## Explanation of Slope on Map on our request for reconsidering your decisions

### **Narrative of Slope Analysis Processes**

Zones 19,20,21,22,23 is where the violation on the June 24th report was asked to be corrected as you can see it has not been corrected to the standard of 3:1 set by state.

# INDEX MAP

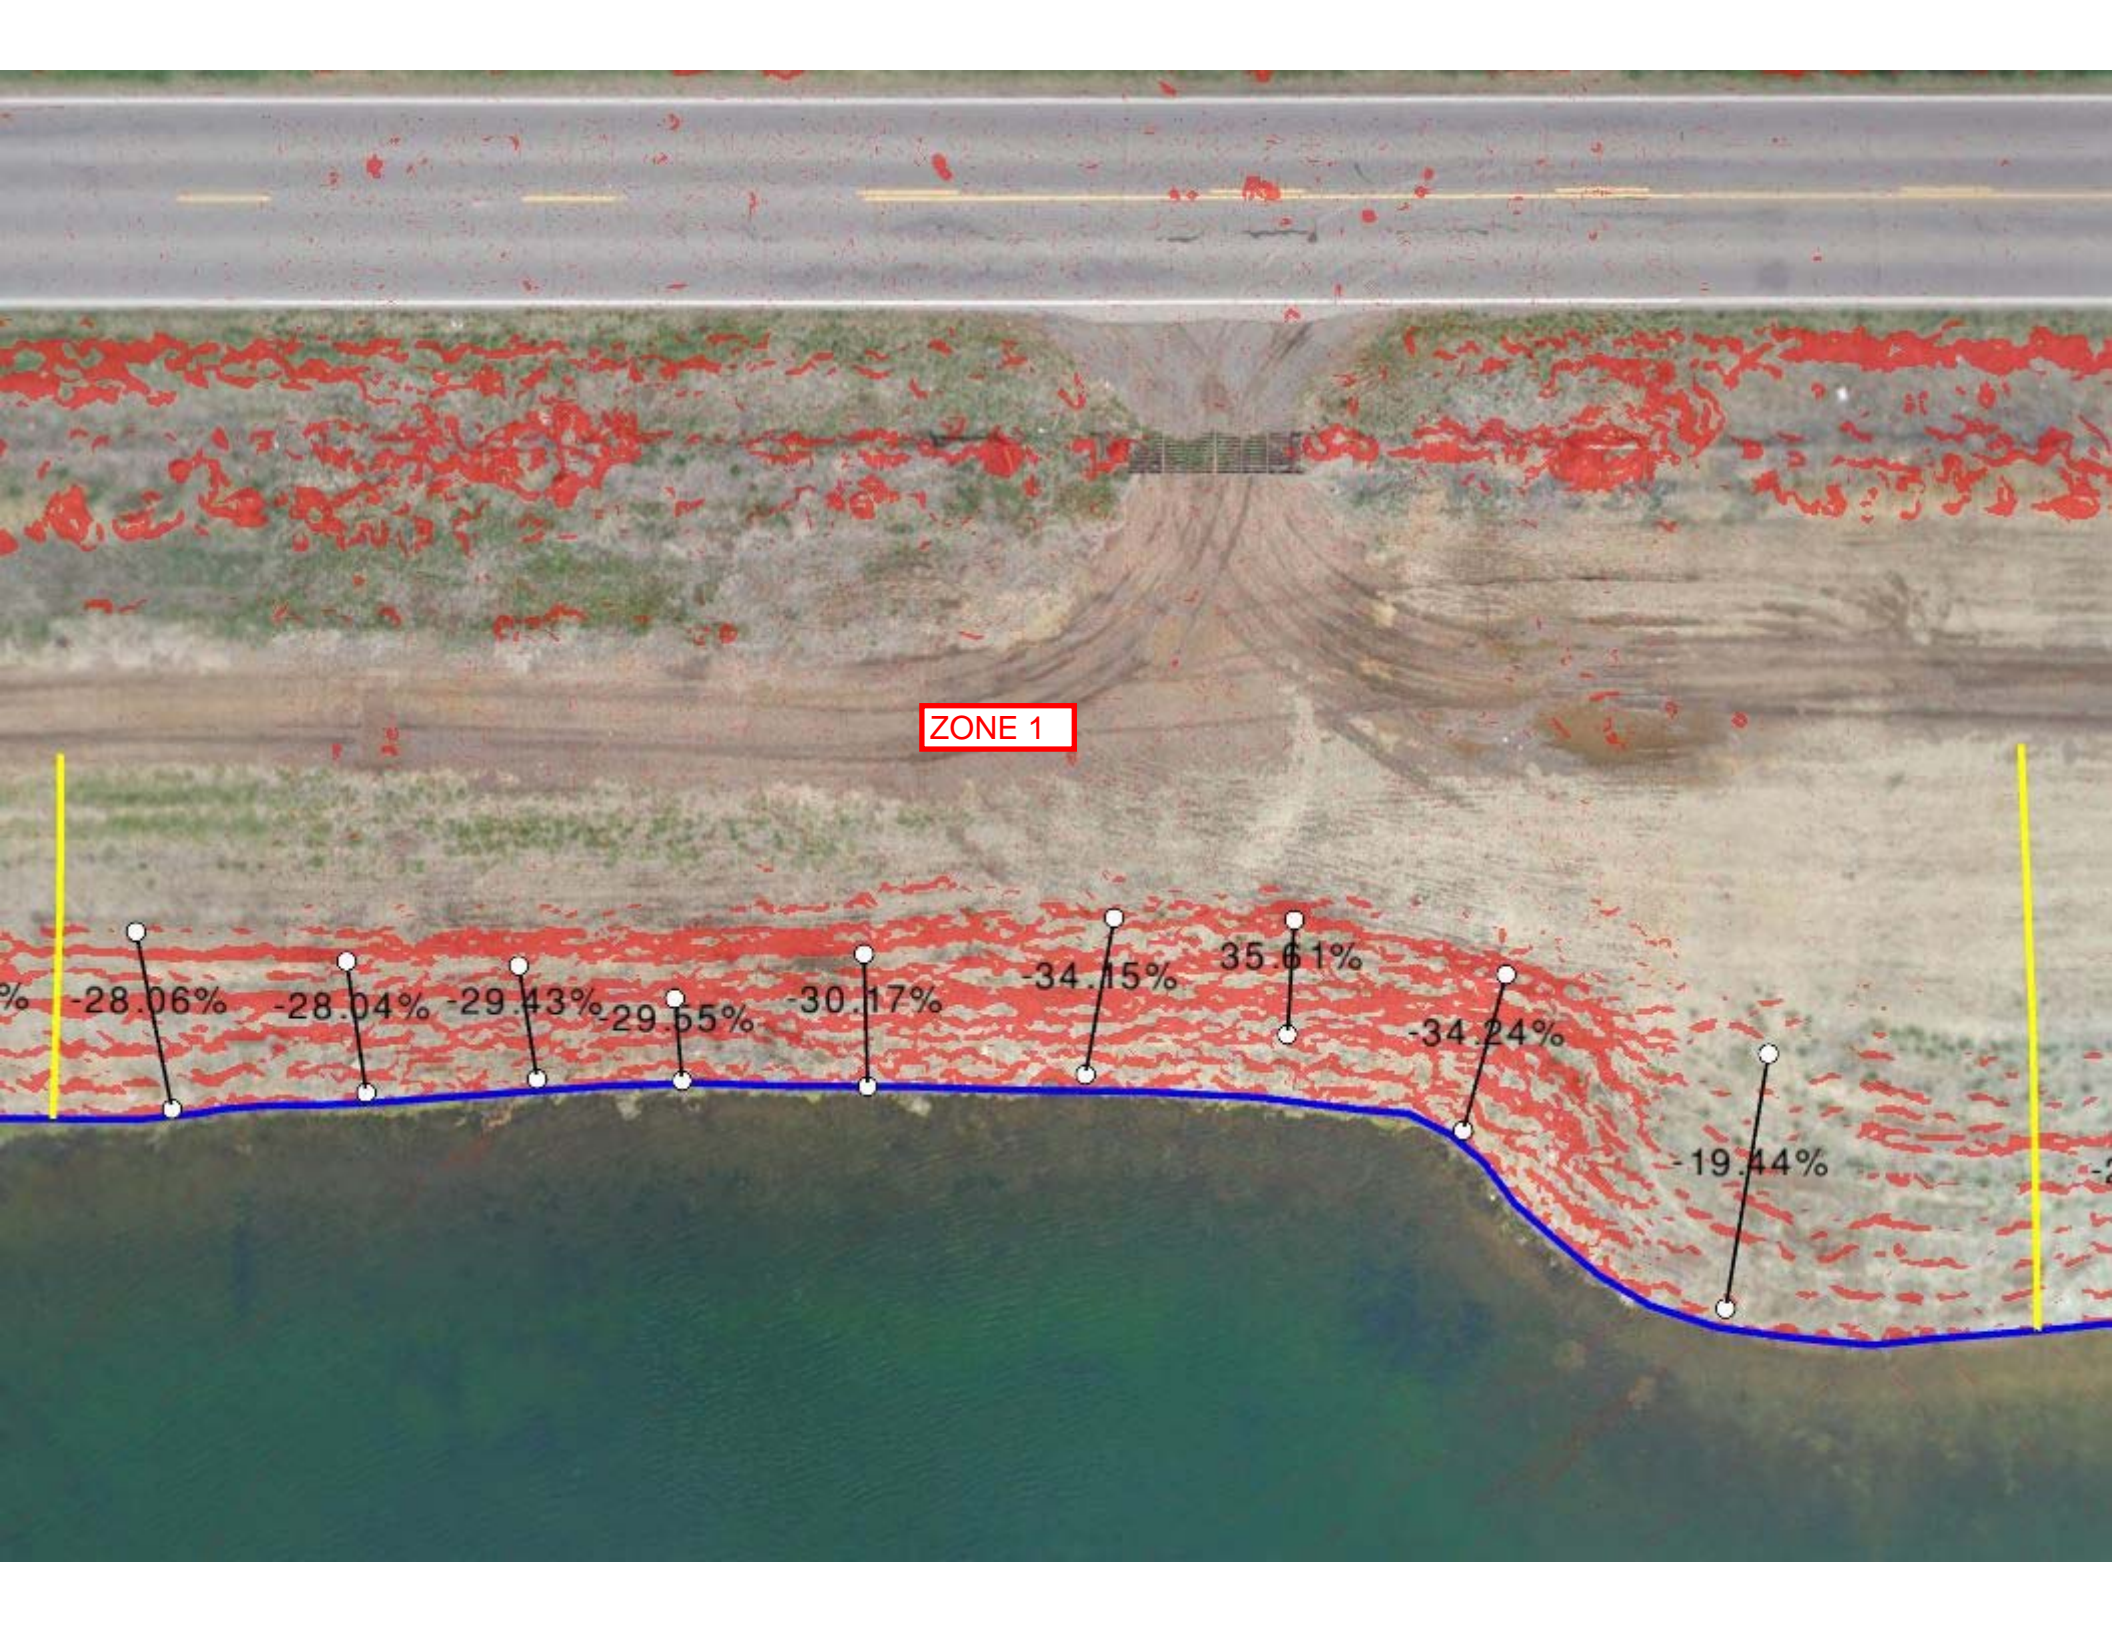
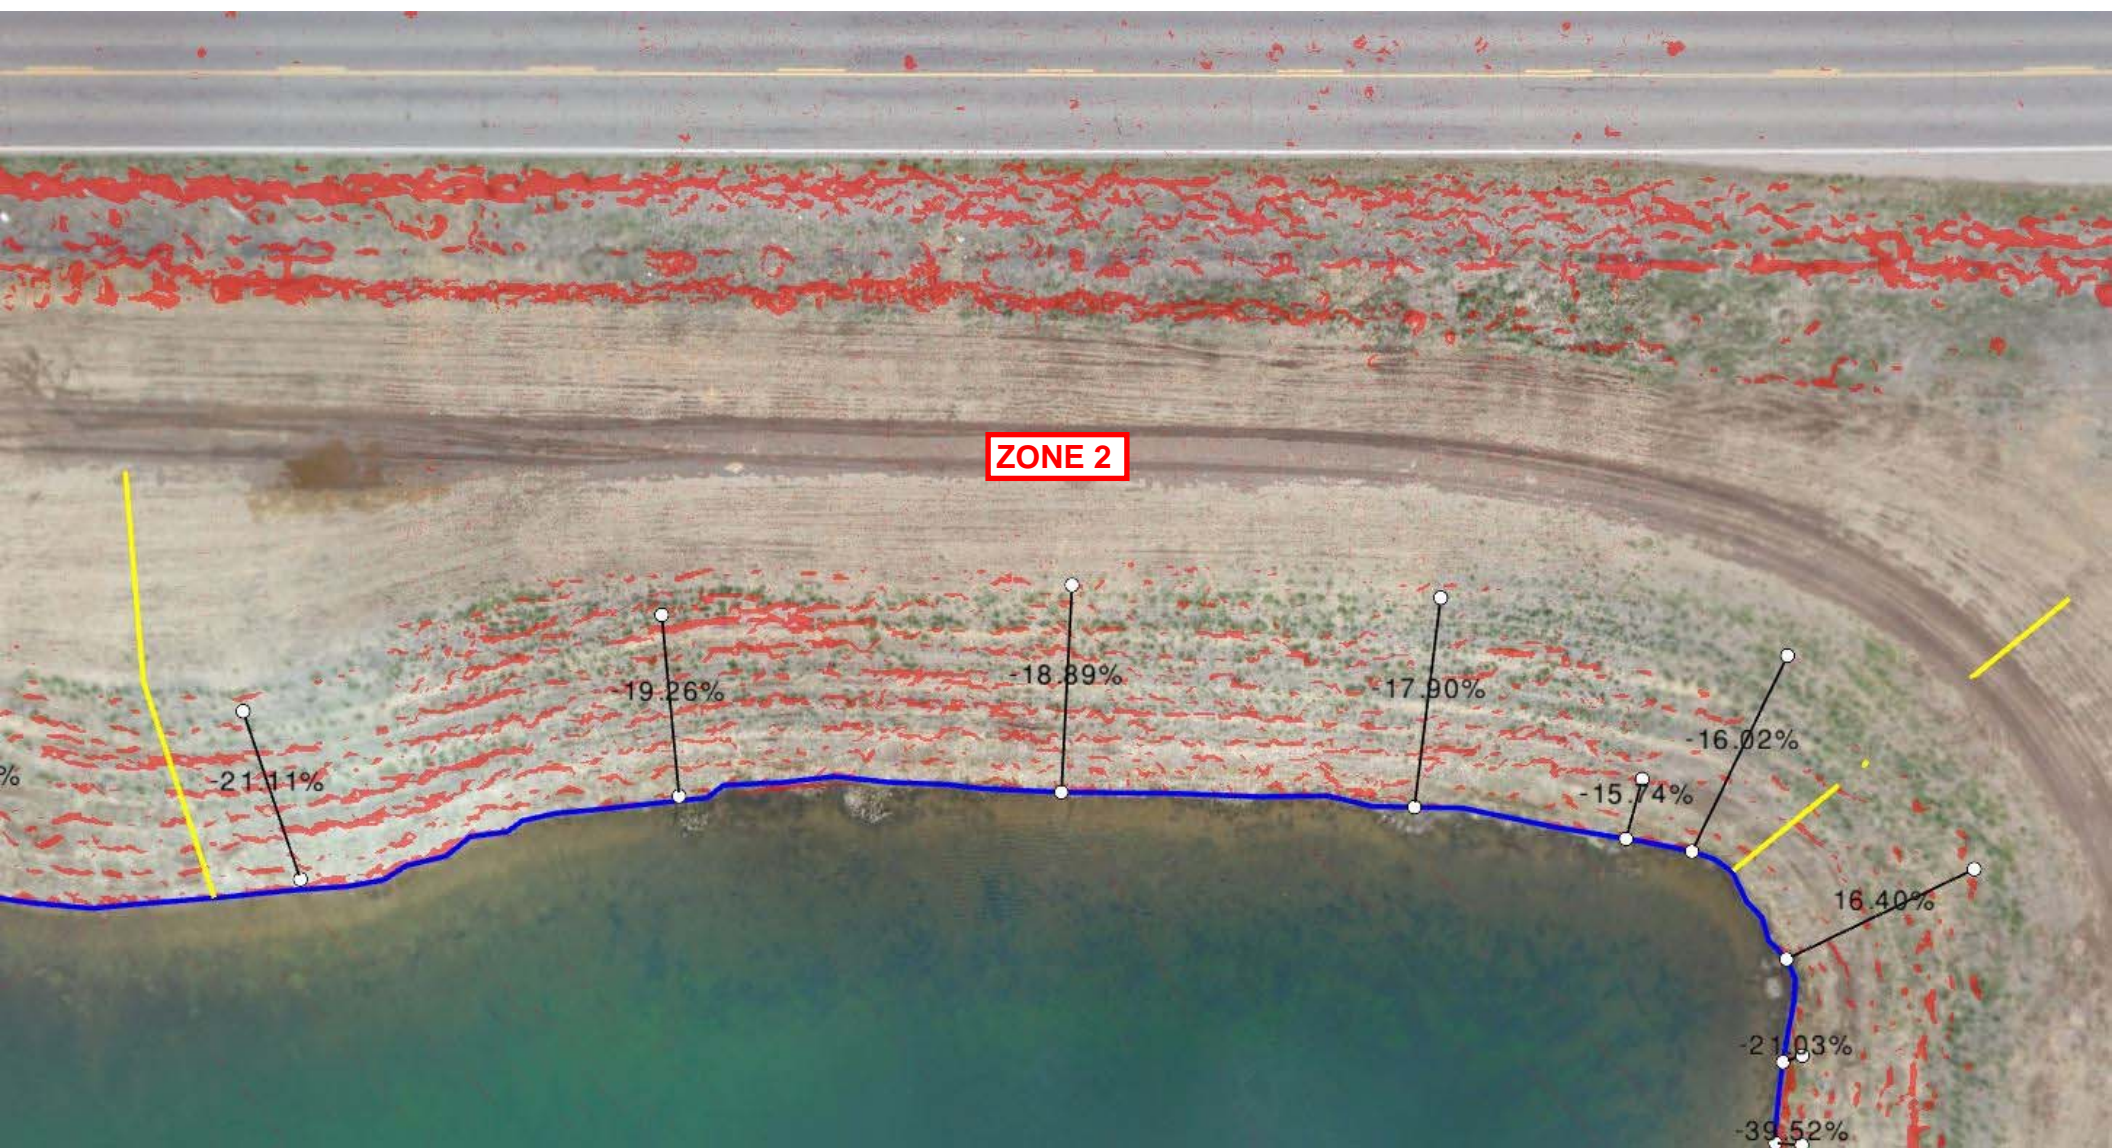
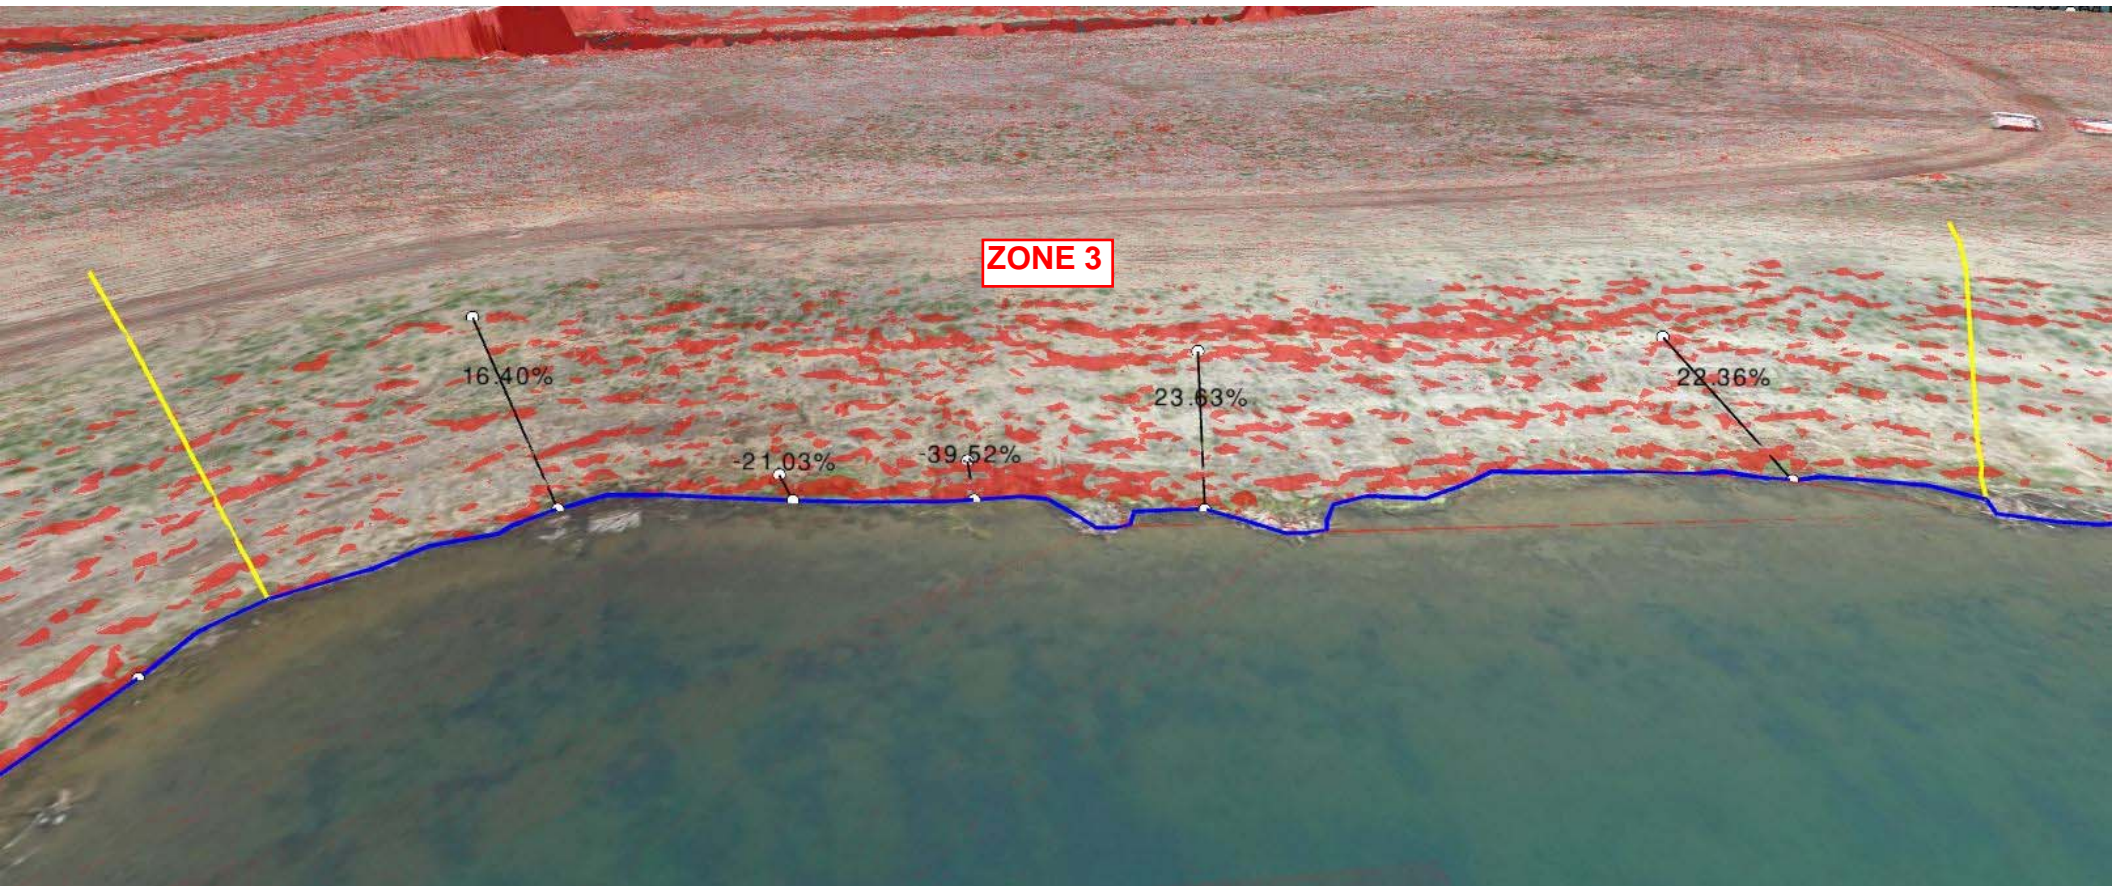
The computer generated analysis shows areas where the slope exceeds 3:1 in RED.

The model indicates wind and wave erosion on the graded slopes along the waters' edge resulting in near vertical faces in some areas. Additionally, there are long slopes where it exceeds 3:1.
